City of Ketchum

Recommendation to Hold a Public Hearing and Approve the Amkay Townhomes Lot Line Shift Final Plat & Findings of Fact, Conclusions of Law, and Decision.

A PLAT SHOWING
AMKAY TOWNHOMES AMENDED
WHEREIN THE PREVIOUS BUILDING FOOTPRINTS ARE REMOVED
LOCATED WITHIN
SECTION 13, T.4 N., R.17 E., B.M., CITY OF KETCHUM, BLAINE COUNTY, IDAHO
MAY 2022

IN RE:)
)
Amkay Townhomes Lot Line Shift) KETCHUM CITY COUNCIL
Lot Line Shift) FINDINGS OF FACT, CONCLUSIONS OF LAW, AND
Date: June 13, 2022) DECISION
)
File Number: P22-030)

Attachment A:
Amkay Townhomes Final Plat

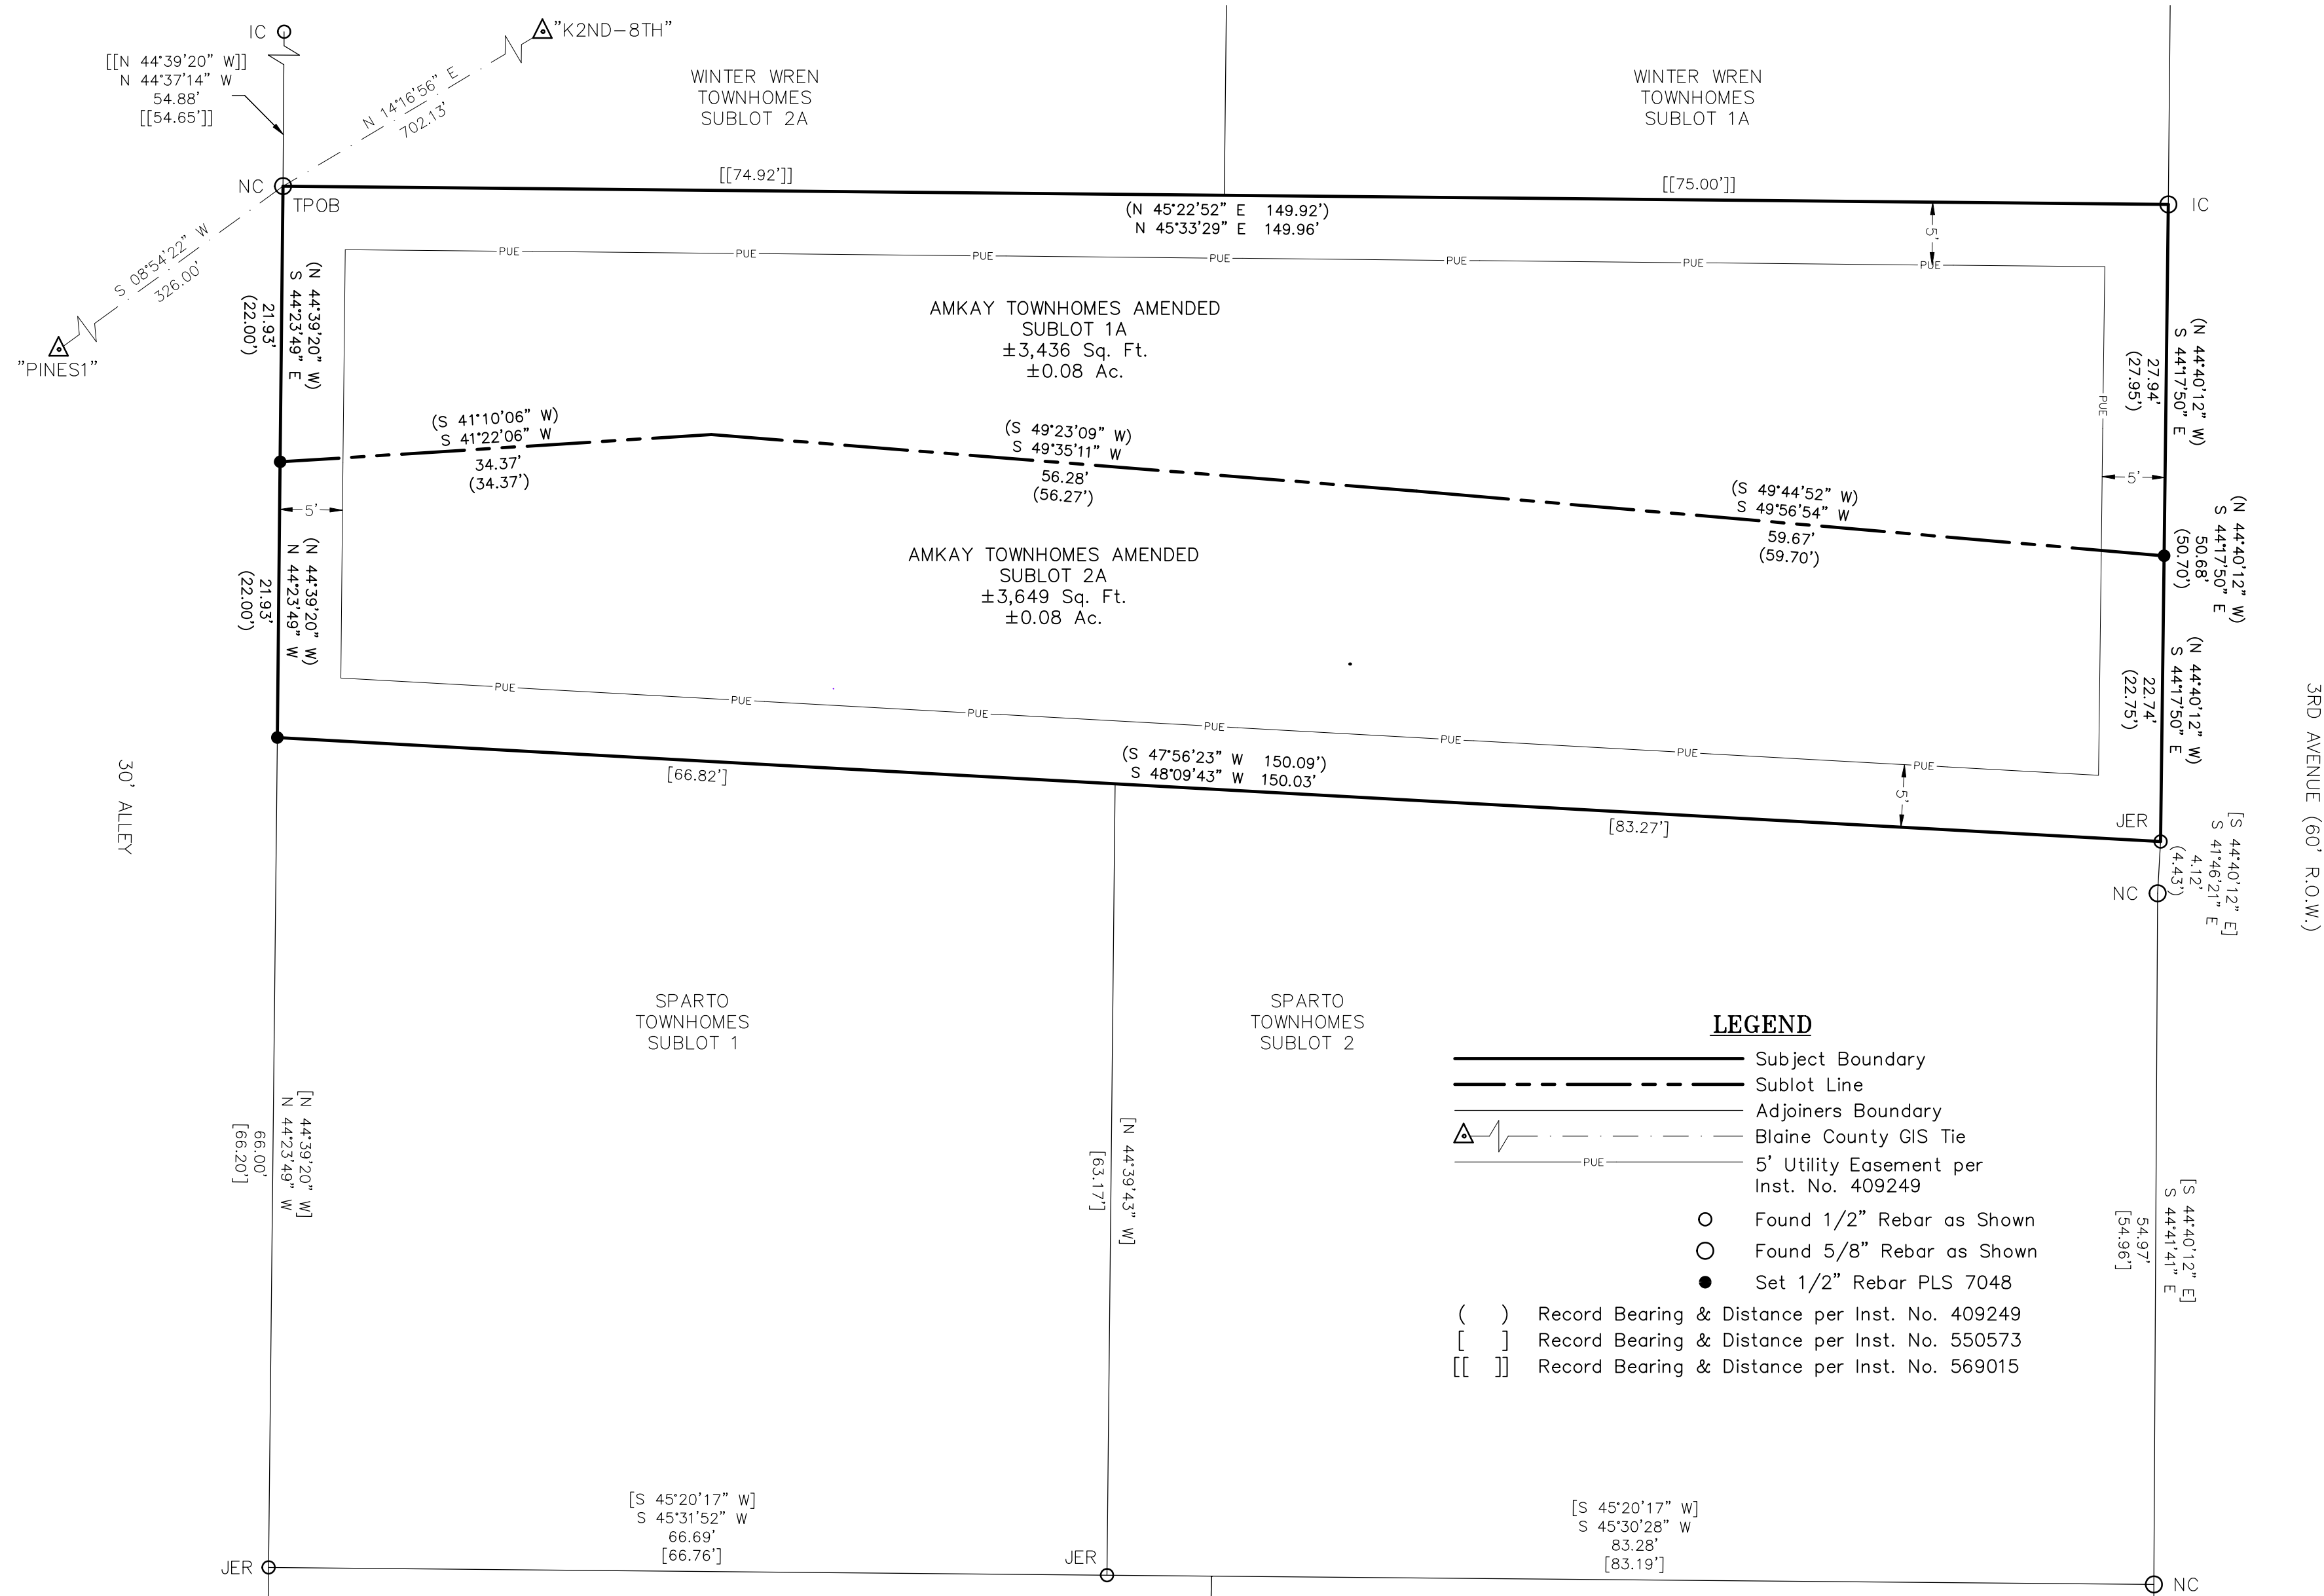
Council Findings	<i>As conditioned, this standard shall be met. The plat mylar shall show a minimum of two Blaine County Survey Control Monuments with ties to the property and an inverse between the two monuments. The Survey Control Monuments shall be clearly identified on the face of the map.</i>
<input checked="" type="checkbox"/>	<input type="checkbox"/>	<input type="checkbox"/>	16.04.030.K.2	Location and description of monuments.
				<i>As conditioned, this standard shall be met. The final plat mylar shall show the location and description of monuments.</i>
<input checked="" type="checkbox"/>	<input type="checkbox"/>	<input type="checkbox"/>	16.04.030.K.3	Tract boundary lines, property lines, lot lines, street right of way lines and centerlines, other rights of way and easement lines, building envelopes as required on the preliminary plat, lot area of each lot, boundaries of floodplain and floodway and avalanche district, all with bearings, accurate dimensions in feet and decimals, in degrees and minutes and radii, arcs, central angles, tangents and chord lengths of all curves to the above accuracy.

Council Findings	<i>The plat indicates 3rd Avenue as well as the public utility easements.</i> <i>As conditioned, this standard shall be met. The final plat mylar shall show tract boundary lines, property lines, lot lines, street right of way lines and centerlines, other rights of way and easement lines, building envelopes as required on the preliminary plat, lot area of each lot, boundaries of floodplain and floodway and avalanche district, all with bearings, accurate dimensions in feet and decimals, in degrees and minutes and radii, arcs, central angles, tangents and chord lengths of all curves to the above accuracy.</i>
<input checked="" type="checkbox"/>	<input type="checkbox"/>	<input type="checkbox"/>	16.04.030.K.4	Names and locations of all adjoining subdivisions.
			Council Findings	<i>The plat indicates the adjacent condominium subdivisions. As this standard shall be met, the final plat mylar shall show the names and locations of all adjoining subdivision.</i>

3. The recorded plat shall show a minimum of two Blaine County Survey Control Monuments with ties to the property and an inverse between the two monuments. The Survey Control Monuments shall be clearly identified on the face of the map.
